44470A-01A

S E R V I C E N O T E

44470A 10 channel multiplexer module for 3499A/B. Includes a screw terminal block

Defective connectors shipped with 44470A, 44471A, 44473A, 44474A

Figure 3: Defective Connector with all pins on one side

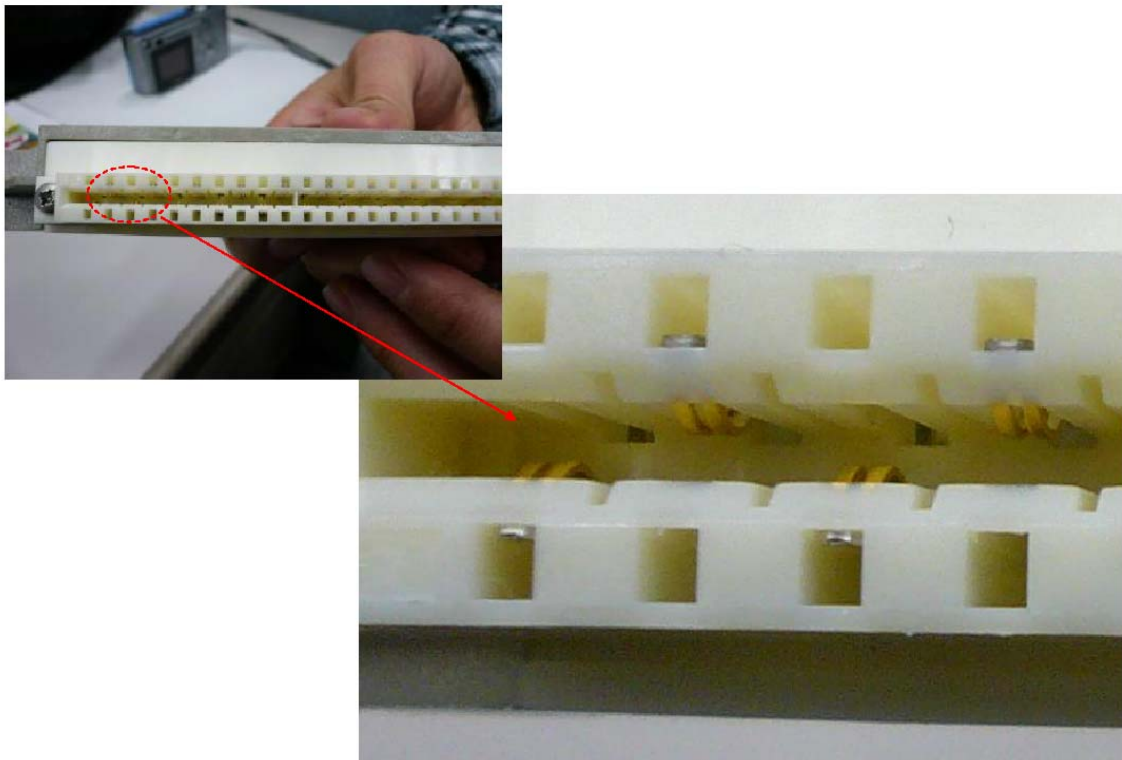
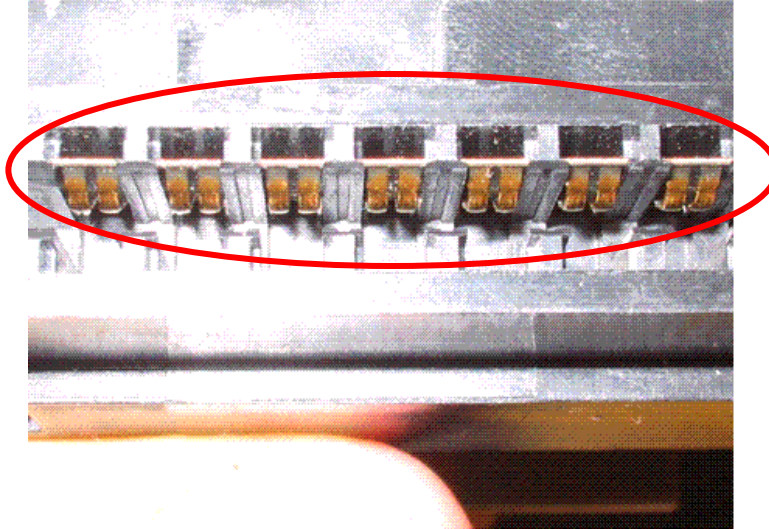
The 44470A, 44471A, 44473A, and 44474A products consist of a main relay plug in module and a removable terminal block (see Figure 1). These are plug in modules for the card cage mainframes 3488A, 3499A, 3499B, and 3499C. The main relay card contains the serial number. The removable terminal module does not contain a serial number. It is possible that over time a terminal block will no longer be used with the same serialized relay card that it was shipped with. A visual inspection of the connector in the removable terminal block is necessary to determine if a defective connector is present. The visual inspection should override the serial number range limits. All white colored connectors are good and have pins that alternate top to bottom (see Figure 2). A black colored connector is bad if it contains all pins on one side of the connector (see Figure 3). A black colored connector is good if it contain pins that alternate top to bottom (not pictured).

The procedure to correct the defective connectors is very simple. One must replace the defective connector with a good connector (see connector part numbers list on page 2). The customer may perform this procedure or have an Agilent-qualified person perform this procedure.

Figure 4: Removing defective connector from terminal block

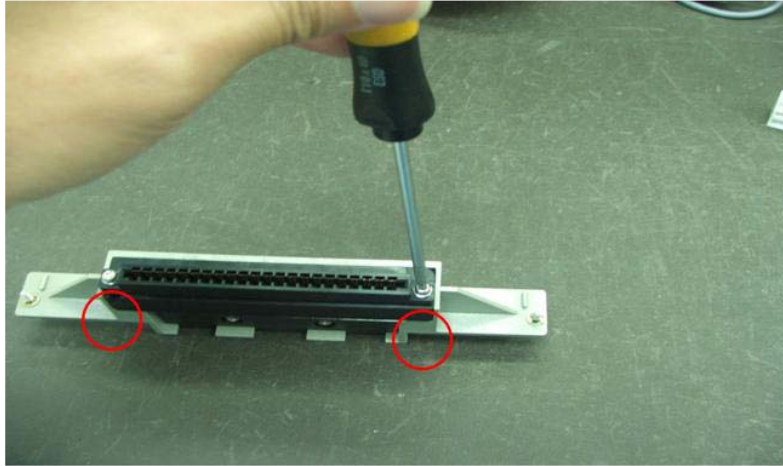
Connector Replacement Procedure: After identifying a defective connector, the connector in the terminal block is repaired by removing the two screws that hold the connector to its case. Note the orientation of the connector. This will release the connector from the terminal block and then a good one can replace it. No soldering is necessary. See Figure 4.

1. Use a T10 torx driver to unscrew the 2 screws of the connector.
